# **PCI Design Handbook**

# Precast and Prestressed Concrete, Eighth Edition

In 2017, the Precast/Prestressed Concrete Institute published the eighth edition of the *PCI Design Handbook—Precast and Prestressed Concrete* (MNL–120–17). The committee devoted significant effort to provide an accurate document, however, some errata have been discovered. The errata published herein is intended to supplement the information provided in the handbook and revise or clarify the printed copy. PCI suggests you mark your copy to reflect all the errata, so that your handbook is as accurate as possible.

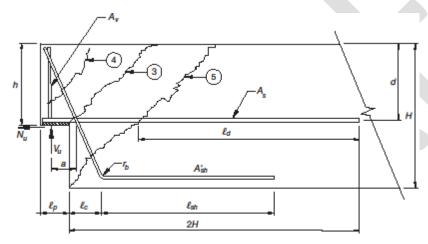
Page 5-76, Figure 5.5.3, top figure: Replace "Center of gravity of flexure reinforcement" with "Critical, minimize, but no higher than center of gravity of flexural reinforcement"

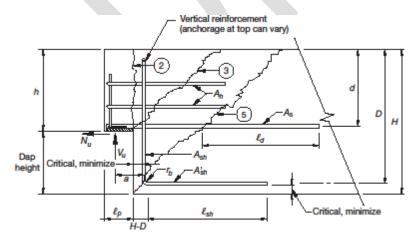
Page 5-78, Figure 5.5.5: Replace current figure with the following:

Dapped end with inclined L reinforcement

Dapped end with vertical reinforcement
